**Re: BASF Cranston - Sediment Sample Collection in Pawtuxet River**

**BASF Cranston - Sediment Sample Collection in Pawtuxet River**

PROPOSED SEDIMENT SAMPLE LOCATIONS

FIGURE 1

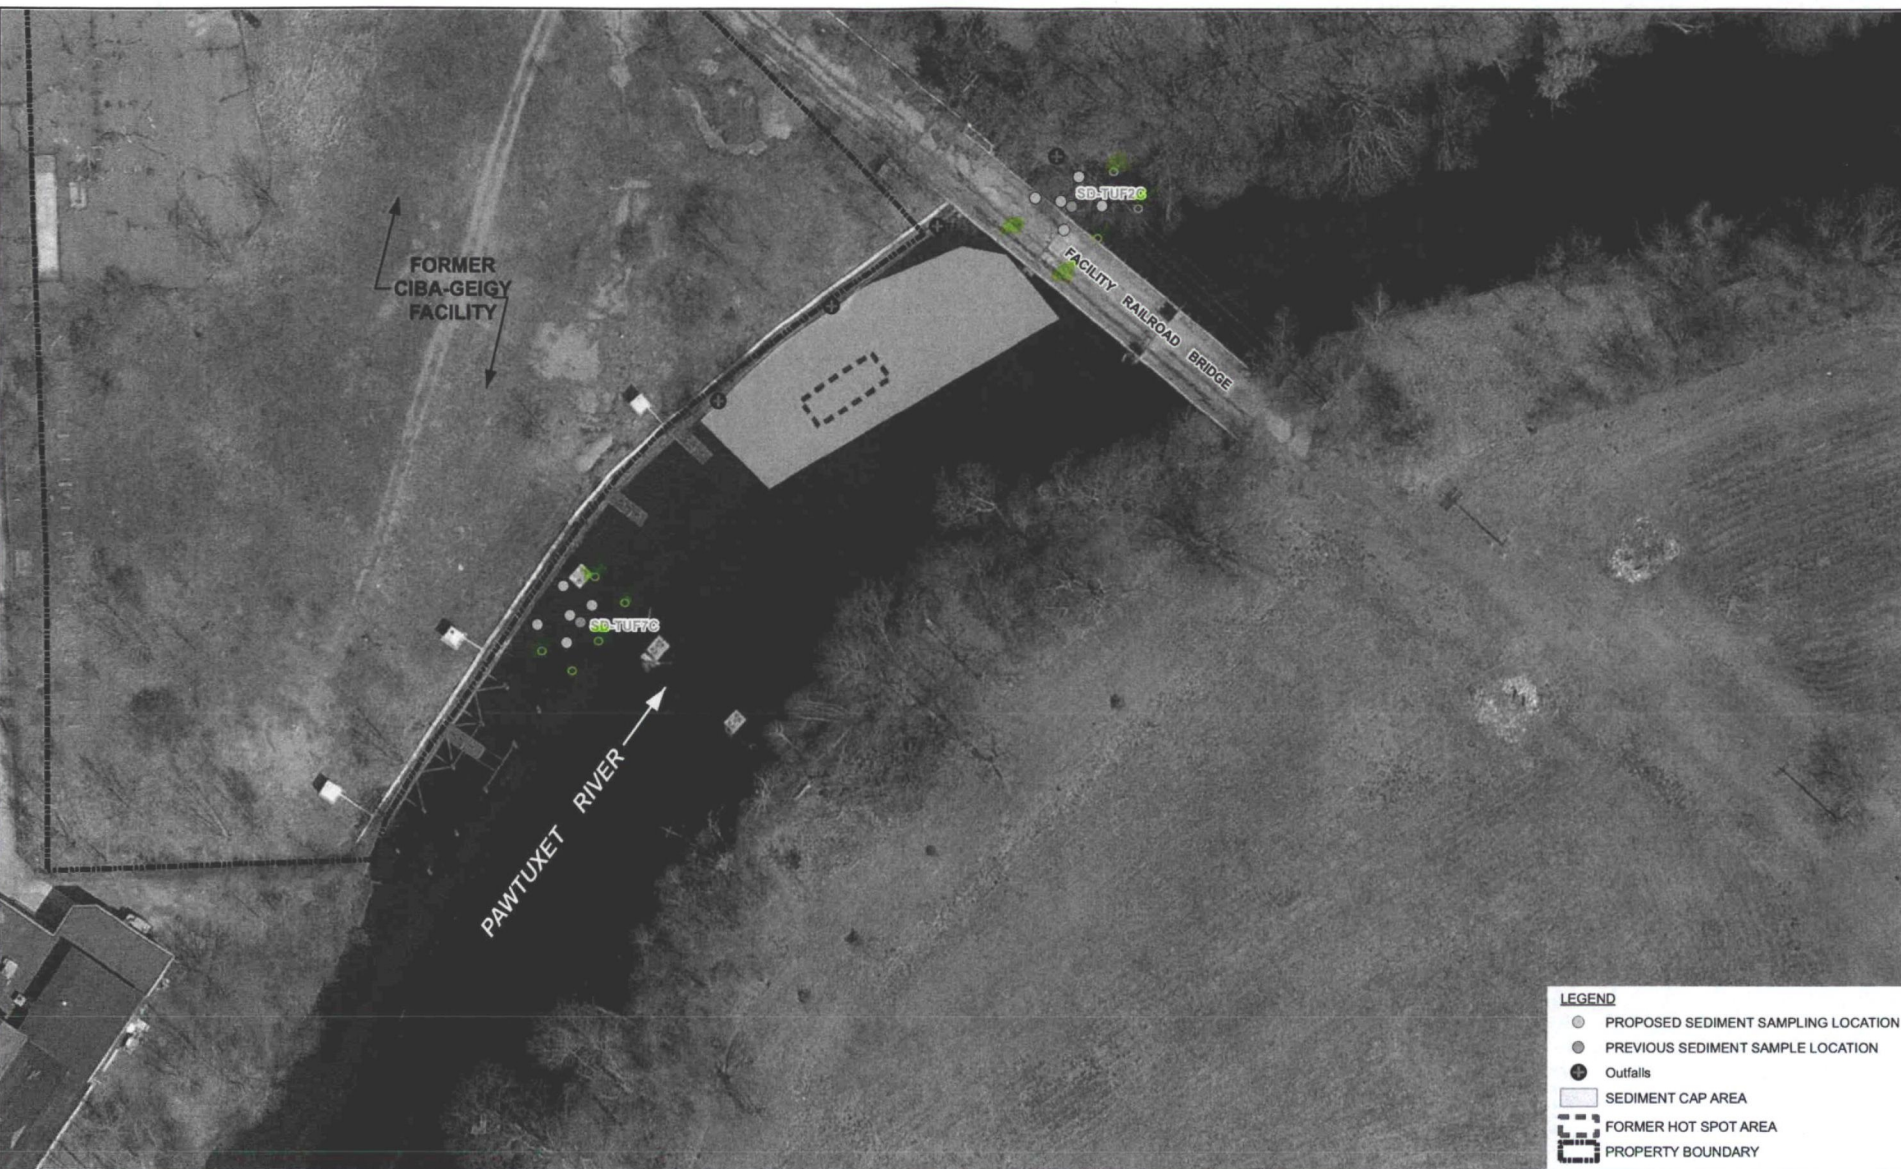
Joe/Joanne, EPA approves the Pawtuxet River sediment sample collection as described in this e-mail.

As we discussed on the phone earlier today, BASF is planning to complete additional sediment sampling and analysis for total PCBs in the Pawtuxet River, adjacent to the former Production Area. The attached Figure 1 presents the proposed sediment sample locations. The goal of this work is to determine if PCB levels at SD-TUF7C and SD-TUF2C are consistent with 1994 data and, if necessary, to provide sediment quality data surrounding those locations that would serve as pre-characterization data for a potential focused removal action.

The historic sediment core locations of SD-TUF7C and SD-TUF2C will be re-sampled and 3 sediment samples will be submitted for total PCB analysis by EPA Method 8082 from each location (0-6", 6-12", 1-2'). Four cores surrounding each of those locations will be collected and samples will be submitted for total PCB analysis. A total of 30 samples will be collected and submitted from 10 locations at three depth intervals (0-6" 6-12", 1-2'), shown on the attached figure as solid blue dots.

An additional 30 samples will be collected from 10 locations at three depth intervals (0-6", 6-12", 1-2') surrounding the samples described above (represented on the attached figure as open green circles) and submitted to the laboratory. The laboratory will freeze the samples upon receipt. These samples will be analyzed for total PCBs by EPA Method 8082 if the results from adjacent, inner samples are >1 ppm total PCBs.
